APPLICATION NO.	FILING DATE	FIRST NAMED INVENTOR	ATTORNEY DOCKET NO.	CONFIRMATION NO.
10/735,374	12/12/2003	Betty Shu Mercer	TI-36853	1822
23494 7590 06/13/2008 TEXAS INSTRUMENTS INCORPORATED P O BOX 655474, M/S 3999 DALLAS, TX 75265			EXAMINER ANDUJAR, LEONARDO	
			ART UNIT 2826	PAPER NUMBER
			NOTIFICATION DATE 06/13/2008	DELIVERY MODE ELECTRONIC

Office Action Summary	Application No.	Applicant(s)	
	10/735,374	MERCER ET AL.	
	Examiner	Art Unit	
	Leonardo Andújar	2826

DETAILED ACTION

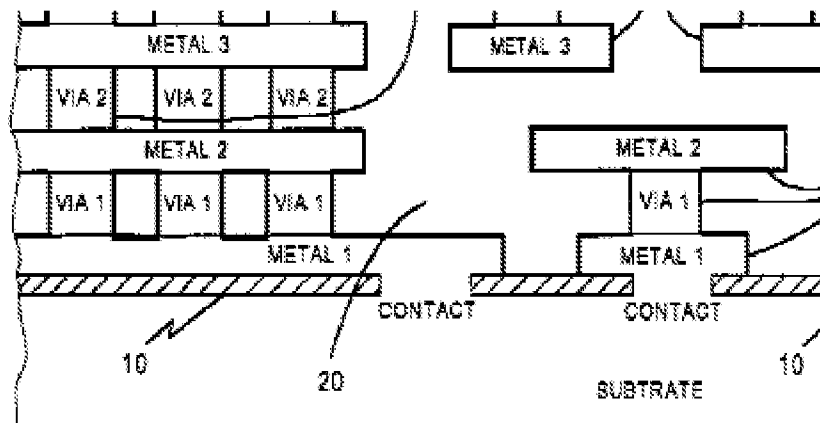
8. Regarding claim 34, Jeong in view of Thomas further in vie of Shih shows that the thick copper substantially overlies at least one of the metal regions.

9. Regarding claim 38, Jeong teaches a copper seed layer 43 formed directly onto the surface of each of the tungsten plugs, wherein the copper seed layer comprises a conductive barrier (e.g. TiN) layer to prevent copper from diffusing into the protective overcoat (col. 3/lls. 66-67 & col. 4/ll. 1).
